ERRATA

Table 9 Shape and dimensions of C-shape plain caliper gauge
For metric coarse and fine screw threads

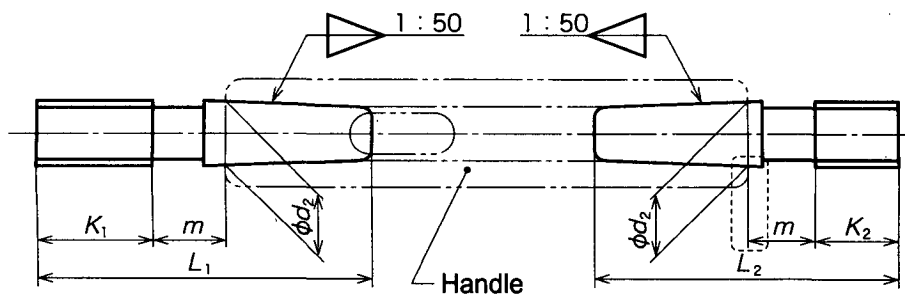
Page	Position	Error	Correct
10	Table 9	Correct diagram is shown in the following page.	
11	Table 10	Correct diagram is shown in the following page.	
25	Table 22	Correct diagram is shown in the third page of this errata.	
26	Table 23 Nominal thread size No.3 to No.5, thick type L_1	21.5	20.5
27	Table 24 Nominal thread size No. 3 to No.5, thick type L_1	21.5	20.5
28	Table 25 Nominal thread size 9/16, 5/8, thick type L_1	52	54
37	Annex Table 3 In the column of "Nominal thread size"	1 3/4, 1	1 3/4, 2
39	Annex Table 5	Correct diagram is shown in the third page of this errata.	
41	Annex Table 7 (2 places in the drawing.)	ϕd_2	ϕd_3
45	Annex Table 11	Correct diagram is shown in the fourth page of this errata.

(Correct)
